## New Richmond Bridge - Bicycle NSW feedback

Thank you for the opportunity to comment on the REF for the New Richmond Bridge and Traffic Improvements Stage 2 project.

There is a missing crossing on the western side (Image: TfNSW)

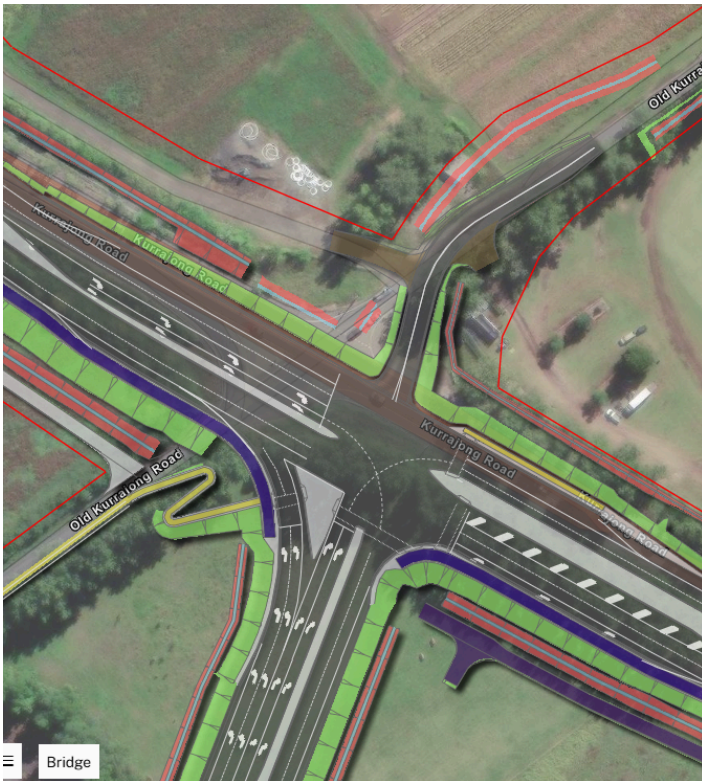
- The new intersection where the bypass connects to Kurrajong Rd **is missing a crossing leg**. This is in contravention of the TfNSW own standard on [Providing signalised crossings on all intersection legs](#). This is typical of the ongoing failure of road projects to align with a raft of excellent NSW Government policies and strategies that aim to improve conditions for active transport. It will be complex to retrofit the intersection in the future. It is much better (and cheaper) to maximise active transport connectivity from the outset.
